Access Compliance Report Public Rights-of-Way (Curb Ramps)

Main Street: BULLARD_RD Cross Street: BULLARD_RD Location: N

ADA ID: RPRK220103145122 Ramp Type: Type 1 - Perpendicular Diagonal Initial Pass/Fail: Pass Overall Compliance: No Severity Score: 2

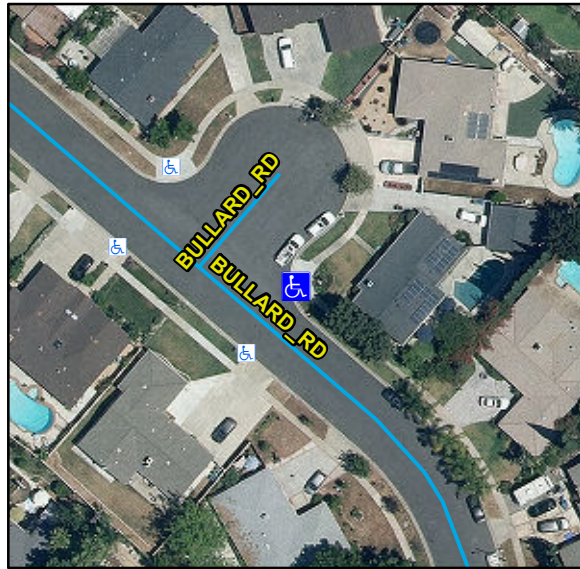
Compliance	Description	Data	Compliance	Description	Data
N/A	Ramp Length (in)	72	N/A	Flare Type LT	
Yes	Ramp Width (in)	48			Sloped
Yes	Ramp Run Slope (%)	7.7	N/A	Flare Slope LT (%)	8.6
No	Ramp Cross Slope (%)	2.1	N/A	Flare Traversable LT	No
N/A	Landing Present	Yes	N/A	Flare Type RT	
N/A	Landing Length (in)	49			Sloped
Yes	Landing Width (in)	48	N/A	Flare Slope RT (%)	3.8
Yes	Landing Run Slope (%)	1.3	N/A	Flare Traversable RT	No
No	Landing Cross Slope (%)	3.3	Yes	DWS Provided	Yes
N/A	Landing Movement Obstructed?	Yes	Yes	DWS Contrast	Yes
	Landing Movement Type	Curb	Yes	DWS Length (in)	36
N/A	Landing Shared	No	Yes	DWS Full Width	Yes
N/A	Clear Space	Yes	Yes	DWS Offset Left (in)	1
N/A	Clear Space To Crosswalk (in)	48	Yes	DWS Offset Right (in)	N/A
N/A	Marked Crosswalk 1	No	N/A	Marked Crosswalk 2	No
	Crossing 1 Direction	W		Crossing 2 Direction	S
	Marked Crosswalk 1 Width (in)	N/A		Marked Crosswalk 2 Width (in)	N/A

N/A	Ramp Inside Crosswalk 1	N/A	Yes	Ramp Inside Crosswalk 2	N/A
	Crossing 1 Slope (%)	4.8		Crossing 2 Slope (%)	5.3
	Crossing 1 Cross Slope (%)	3.1		Crossing 2 Cross Slope (%)	3.1
Yes	Gutter Ponding	No	N/A	Curb Slope	2.8
Yes	Gutter Lip Height (in)	0		Road Run Slope (%)	1.9
Yes	Gutter Run Slope (%)	2.8		Road Cross Slope (%)	5.2
Yes	Gutter Cross Slope (%)	1.9			
Yes	Overall Surface Condition: Acceptable		Yes	Perp Joint Present	Yes
	Cross Gutter Present?	No		Spandrel Present?	No
	Replace Cross Gutter?	N/A		Replace Spandrel?	N/A

Possible Solutions:

Remove & Replace Curb Ramp With Two New Directional Ramps or Equivalent.

R304.5.3, R304.2.1, STD 1115
